SAN ANTONIO WATER SYSTEM
CRESCENT PARK BOOSTER
STATION PROJECT
SAWS Job No. 12-6006
SAWS Solicitation No. B-12-043-CM

ADDENDUM NO.3
October 26, 2012

SITE LAYOUT
SAN ANTONIO, TEXAS

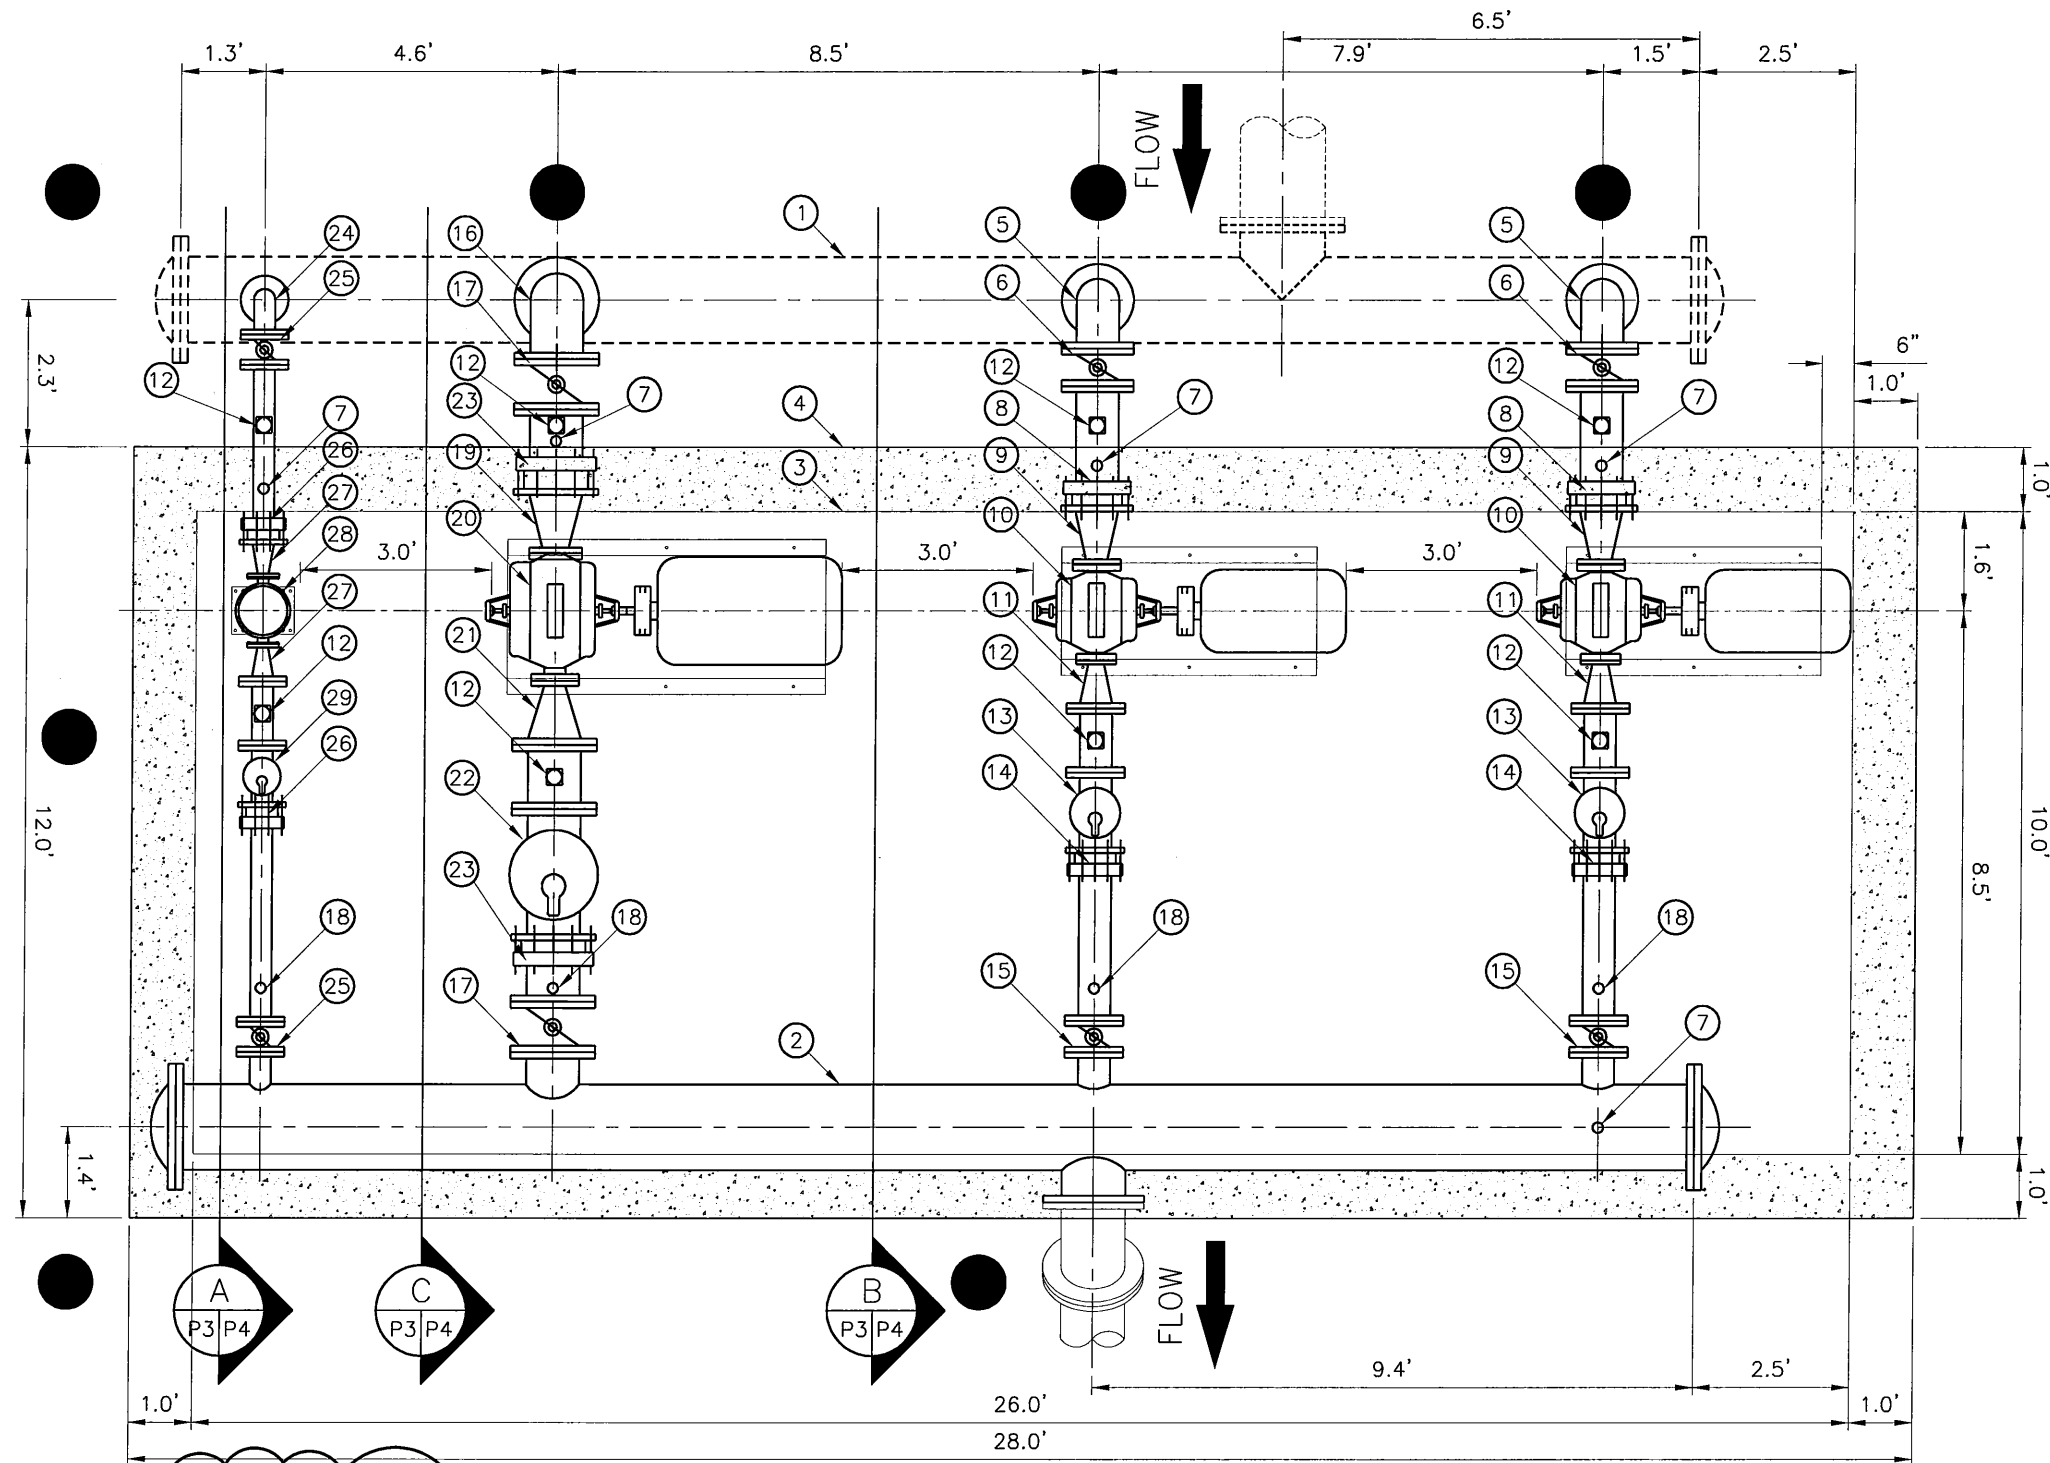
- Q7:** Air line to HP tanks – where is the compressor, what size is the pipe and what kind of pipe? Site Information Item 11 on sheet P2 points to a pipeline.

- A7:** *Item 11 on Sheet P2 indicates the air compressor pad locations. The sheet has been revised to clarify further. See Sheet P5 and P6 also for location of the air compressor pads. Size and type of piping for the air lines shall be per hydropneumatic tank system manufacturer’s recommendations.*

PUMP STATION SECTION

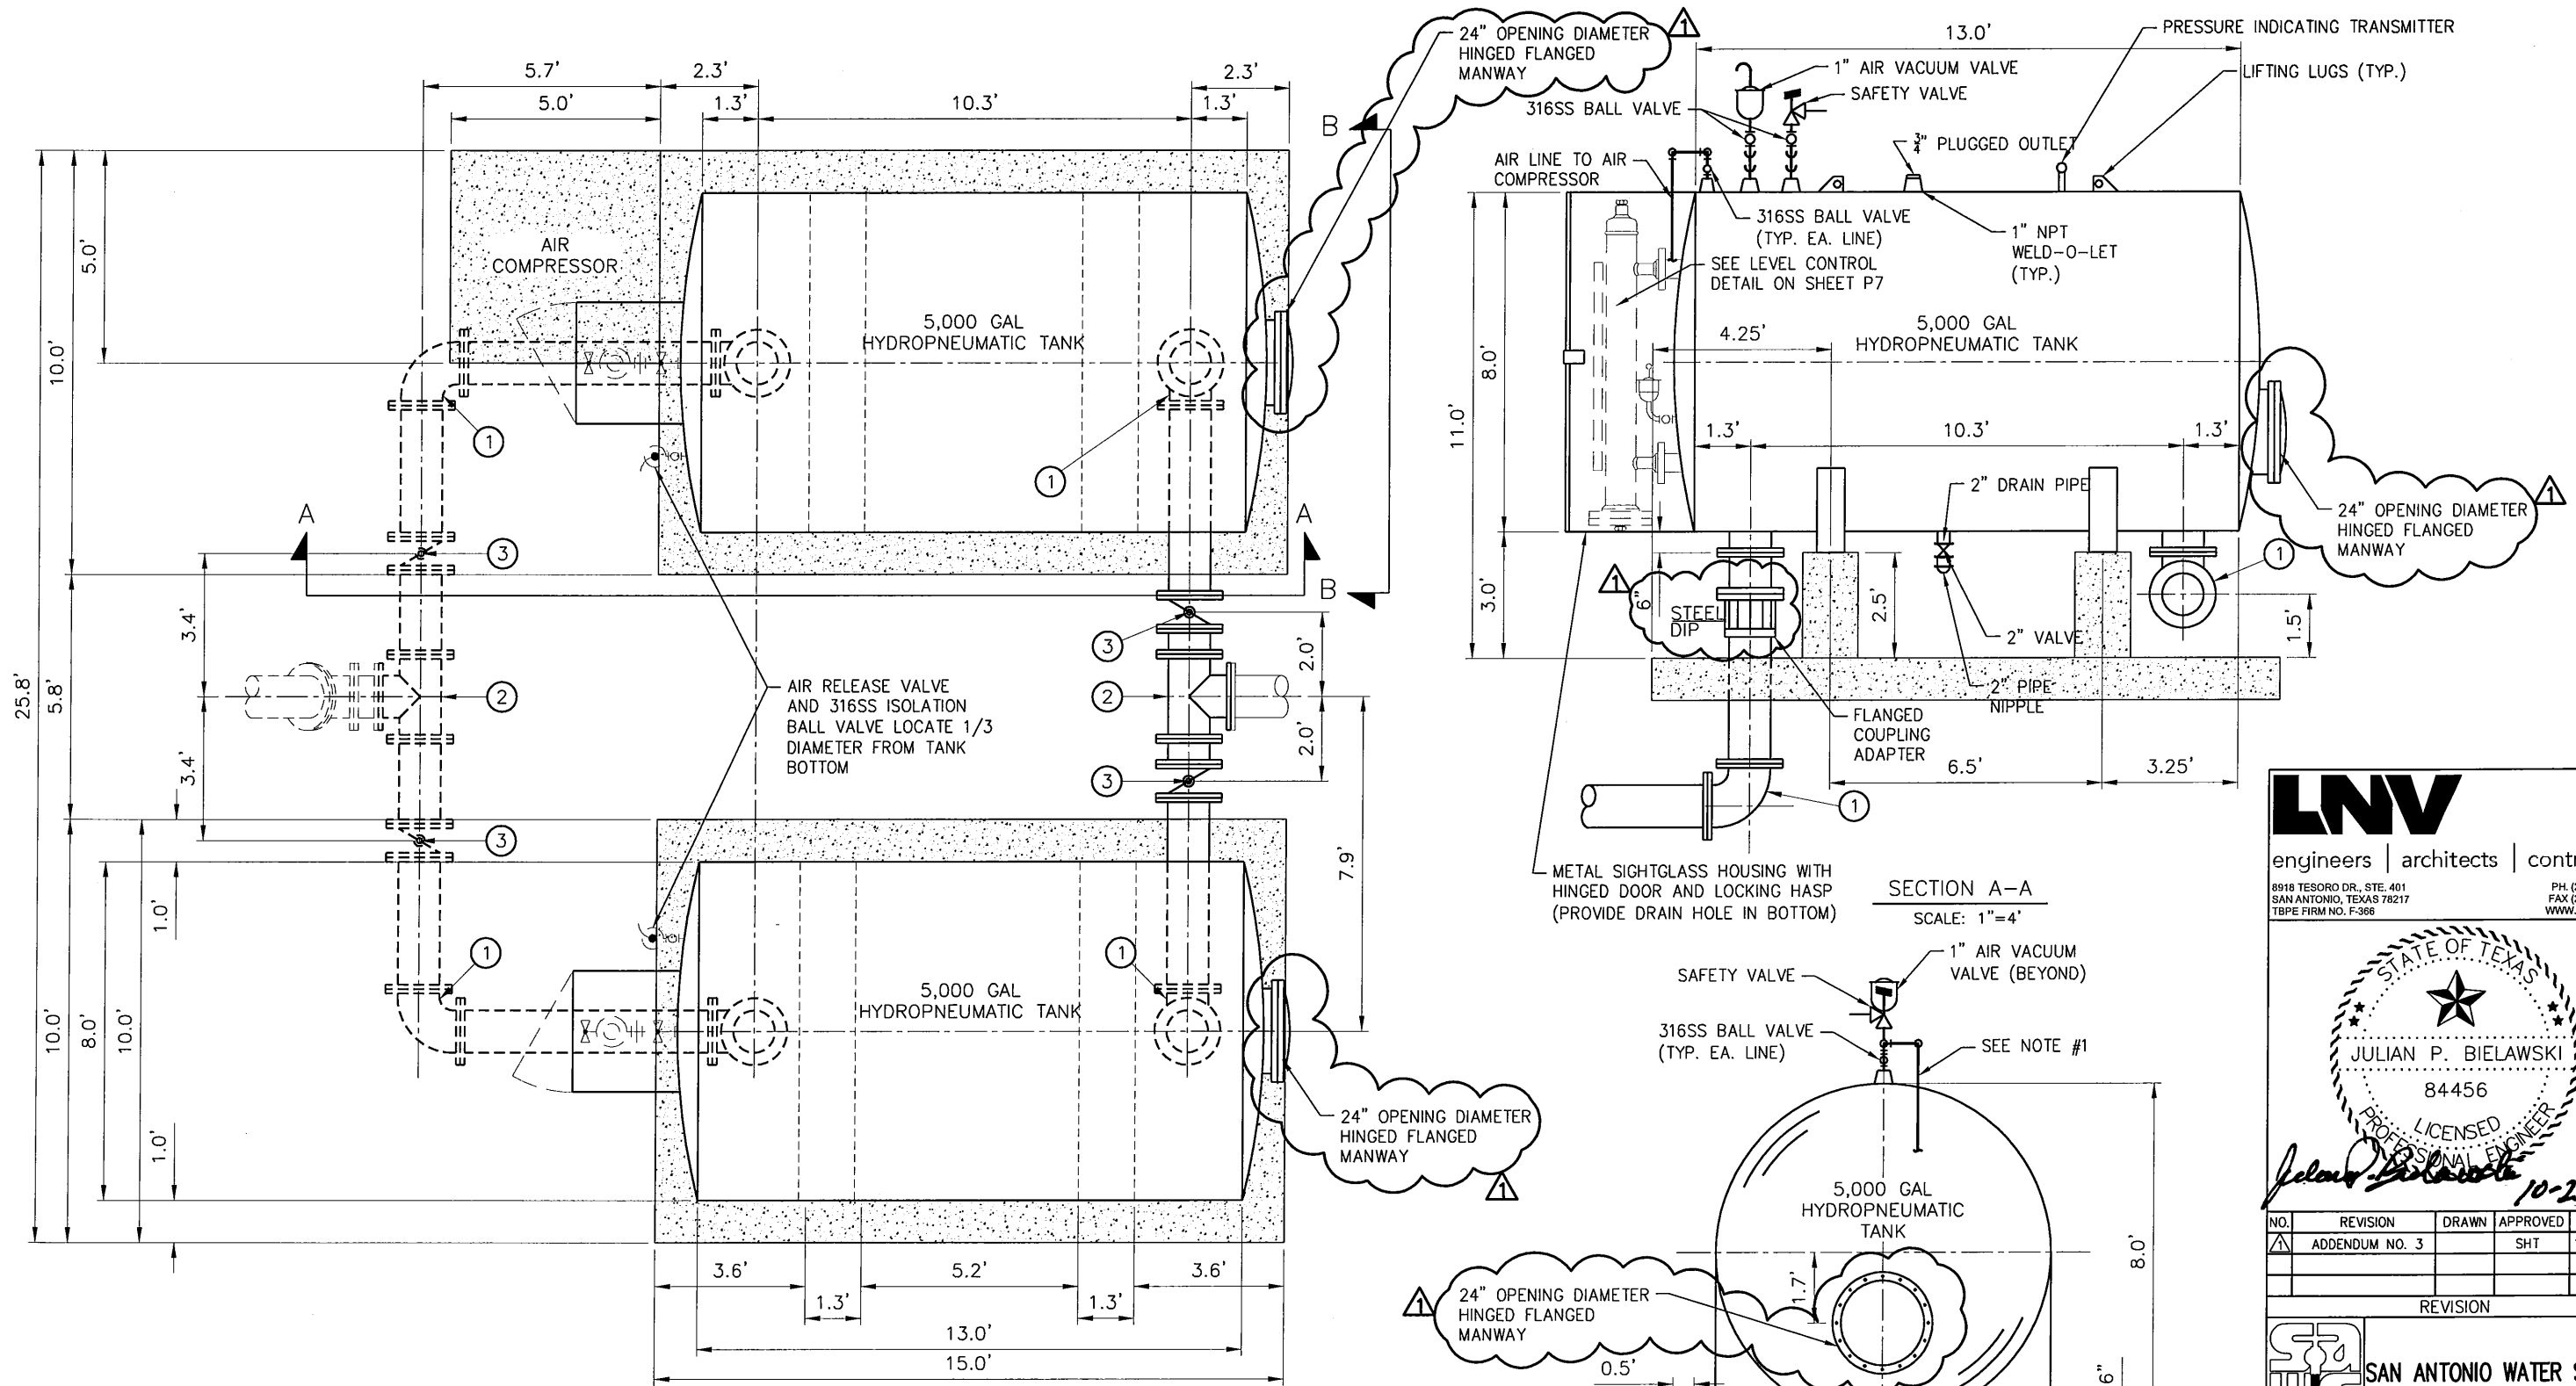
- A6:** *The suction header is separate from the pump skid. The suction header and below ground vertical piping will be ductile iron and will transition to steel piping above ground. See attached revised Sheet P4.*

- Q9: At the Booster Station, please provide the point of transition from the underground DIP to the above ground Steel piping. Is the piping in the PRV vault DIP or Steel?

- A9: *Sheets P4, P5, P6, and P8 have been revised to indicate the points of transition from ductile iron to steel. Piping inside the PRV vault will be Steel.*

SAN ANTONIO WATER SYSTEM
CRESCENT PARK BOOSTER STATION
**DISCHARGE SIDE
DUAL 5,000 GAL
HYDROPNEUMATIC
TANK LAYOUT**
SAN ANTONIO, TEXAS

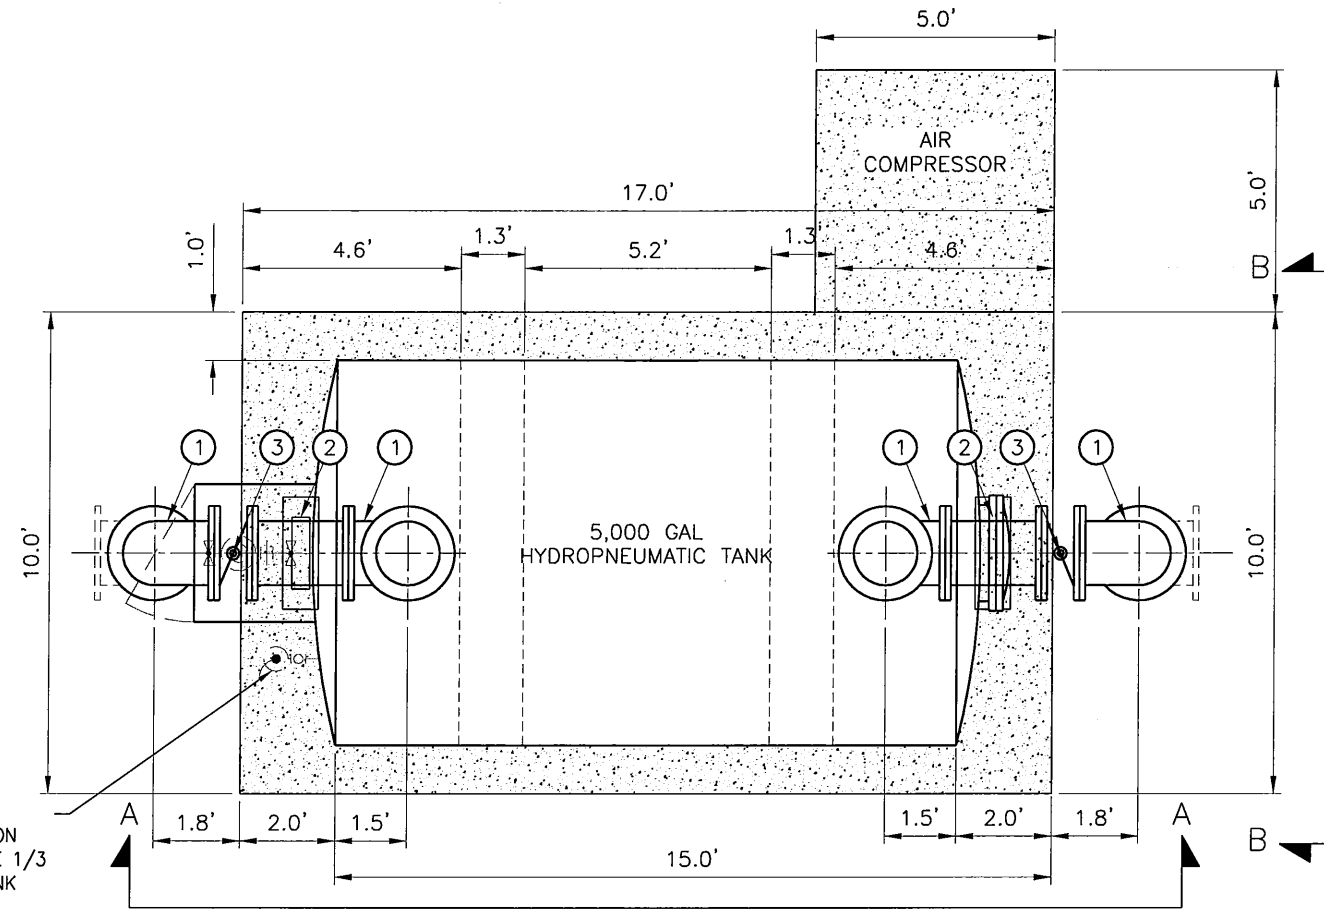
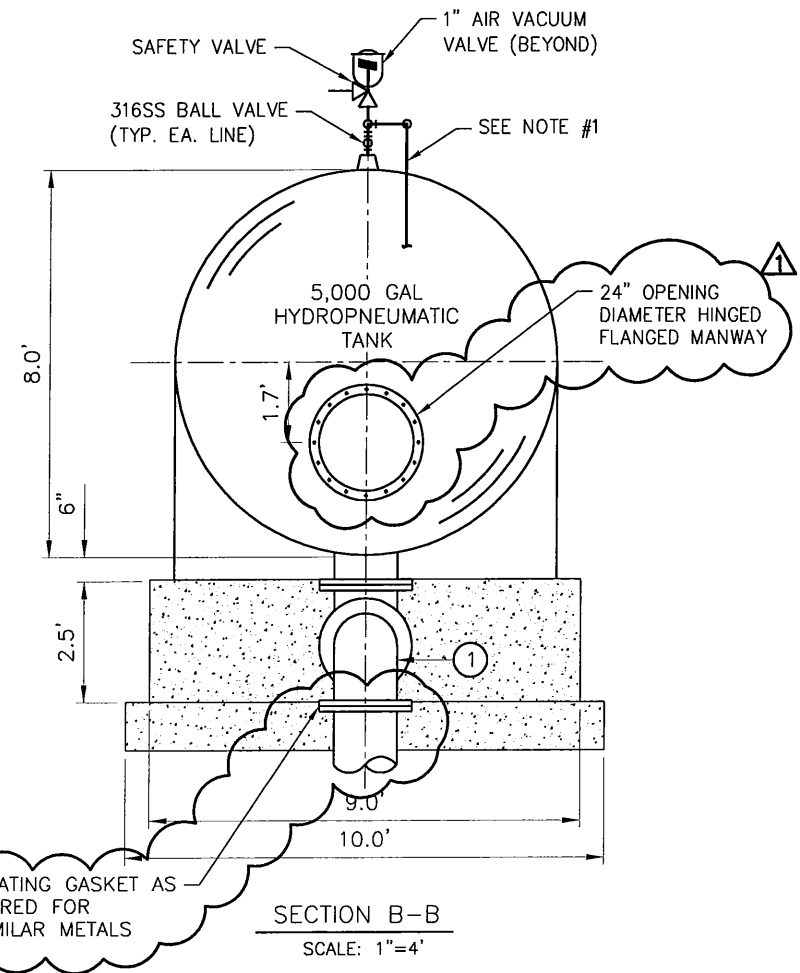
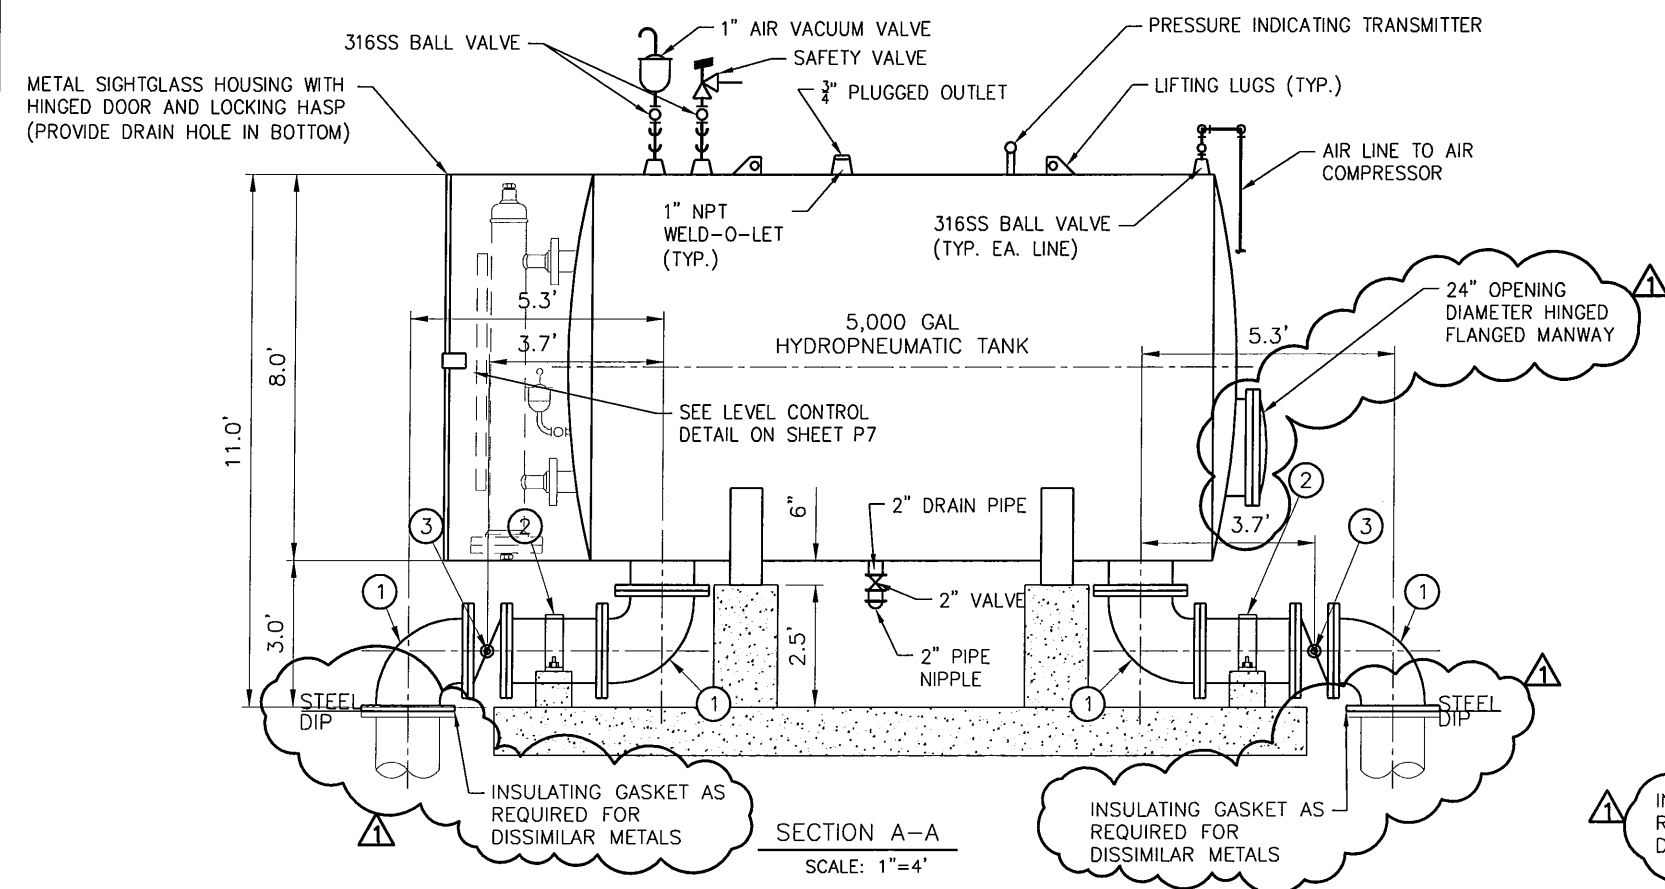
A27: *Refer to attached revised drawings P5 and P6 and revised Hydropneumatic Tank System Specification Section 15500 for Saddles, Inlets/Outlets and Manway requirements. Sight Glass Enclosure shall be located as shown on drawings.*
